**Report to the Future Melbourne Committee**

Future Melbourne Committee  
13 April 2021**Planning Permit Application: TP-2020-89****Queen Victoria Market (Trader Shed), 16-94 Peel Street, MELBOURNE****Presenter:** Larry Parsons, Practice Leader Land Use and Development**Purpose and background**

**DELEGATED PLANNING APPLICATION REPORT**

<b>Application number:</b>	<b>TP-2020-89</b>
<b>Applicant:</b>	<b>Tract Consultants Pty Ltd on behalf of the City Of Melbourne</b>
<b>Owner:</b>	<b>City Of Melbourne</b>
<b>Architect</b>	<b>NH Architecture</b>
<b>Address:</b>	Queen Victoria Market, 16-94 Peel Street, MELBOURNE VIC 3000
<b>Proposal:</b>	Development of the new Trader Shed, including associated demolition, buildings and works and alteration of access to a road in a Road Zone - Category 1.
<b>Cost of works:</b>	\$22,000,000
<b>Date of application:</b>	5 February 2020
<b>Responsible officer:</b>	Ryan Cottrell, Senior Urban Planner

Figure 20 – Roof plan showing gable roof form adjacent to Queen Street and roof plant

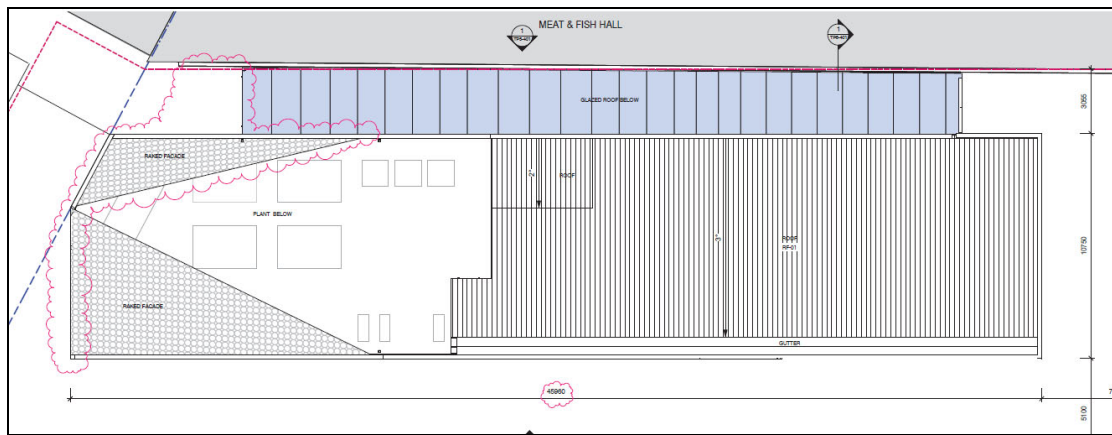
Heritage Victoria were not supportive of the materials and design of the proposal as detailed above. In consultation with the application, Heritage Victoria has resolved to issue Heritage Permit P30767 based on the changes described below as shown in the plans prepared by NH Architecture, dated August 2020. These drawings will be referred to as the **Discussion Plans**.

- Insert an additional level of basement.
- Relocate part of the roof plant to Basement Level 03.
- Increasing the number public toilets at Ground Level and Basement Level 01. They will no longer be unisex.
- Reshaping the building's form and scale to Queen Street via a gable end roof with heights being relative to the adjacent sheds. The maximum height is not increasing or decreasing (remaining at 10.22 metres).
- Replacement of galvanised street and aluminium panel to face brick.
- Reduction in perforated aluminium and change to perforated galvanised steel to the upper rear parapet and plant enclosure.
- Change red translucent façade elements to clear and opaque panelling.
- Inclusion of concrete and galvanised steel lintels.
- Replace the existing gates with two sets of drop chain bollard system at either end of the southern laneway.

- Roof plant is relocated to the basement to allow from a more respectful gable roof form which also lowers the building height at the north-west corner fronting Queen Street.
- Replacing the more contemporary materials with brick to respect the adjoining built form and soften the appearance of the proposed building against the Meat and Fish Hall (Figure 27 and Figure 28).

**Figure 29 - Tree locations that may cause sightline issues**

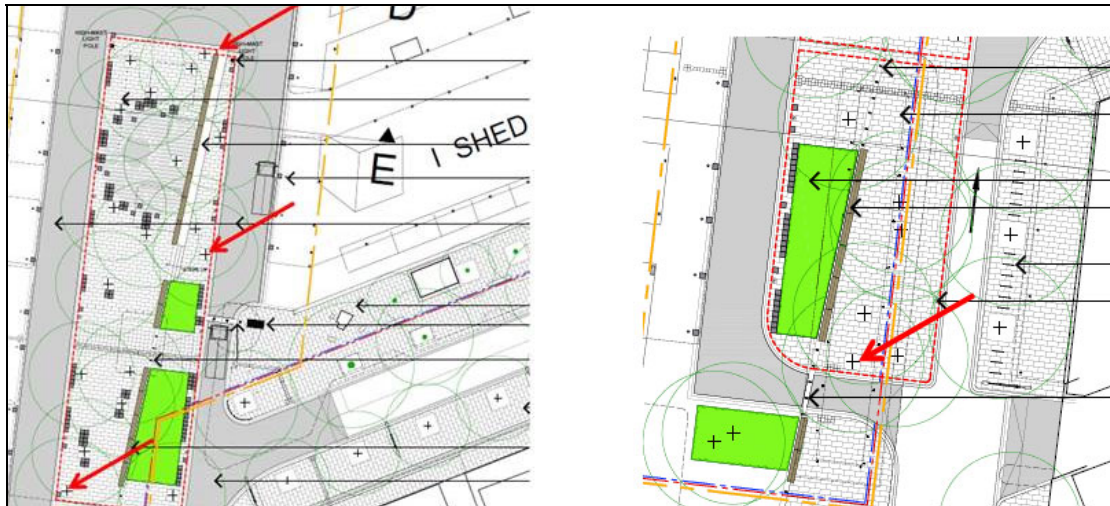
- Confirmation of the location of below ground services – existing and proposed. This is critical in determining the feasibility of structural soil cells.
- Confirmation of soil depths and volumes. This is critical in determining the viability of proposed tree planting. As we are aware the extent of excavation will be limited by previous land use (cemetery).
- Confirmation if irrigation systems are to be proposed as it appears none are shown. This will be critical to tree health.
- Verification that the proposed locations for tree planting will not interfere with sightlines. The clip below shows locations of new trees that seem too close to the edges of the structural soil area and less favourable ground (vehicle access). Some examples are identified by the red arrows (Figure 29):

**Figure 30 – Proposal at Queen Street (Discussion Plans)**

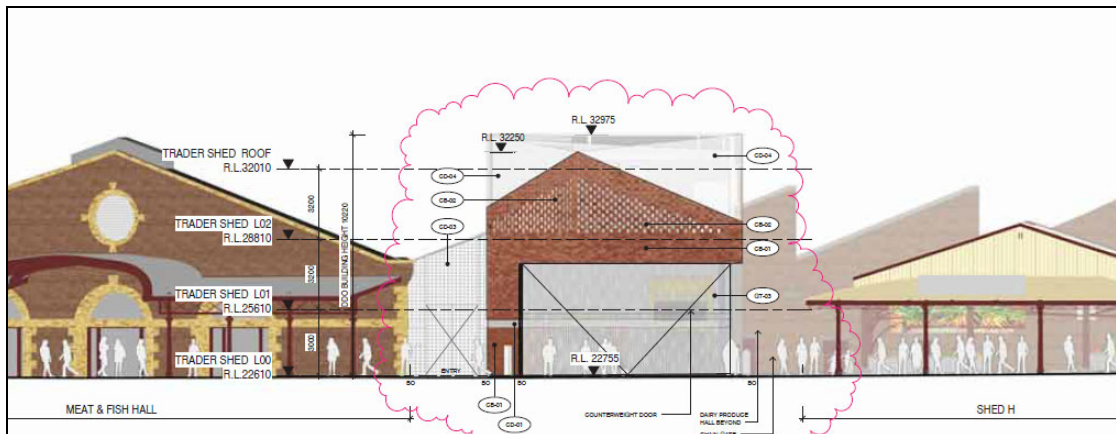
**Access and Safety (Clause 22.01-9)**

The proposal inserts higher levels of activation and does not introduce any unsafe alcoves or entrapment spaces.

**Figure 31 – Elevation showing Meat and Fish Hall behind**

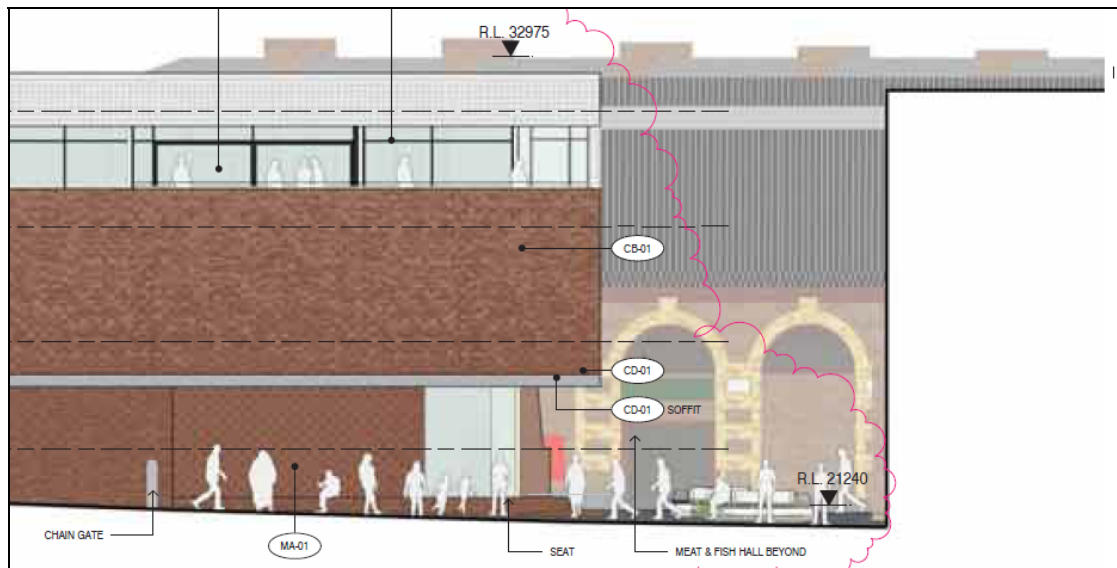
- The height of the building is scaled to align with the existing buildings surrounding the proposal and does not detract from the surrounding buildings. The proposal achieves this through inserting a building of a similar height to the Meat and Fish Hall to the north and the Dairy Produce Hall to the east; both of which are higher than 7 metres (Figure 31 and Figure 32).
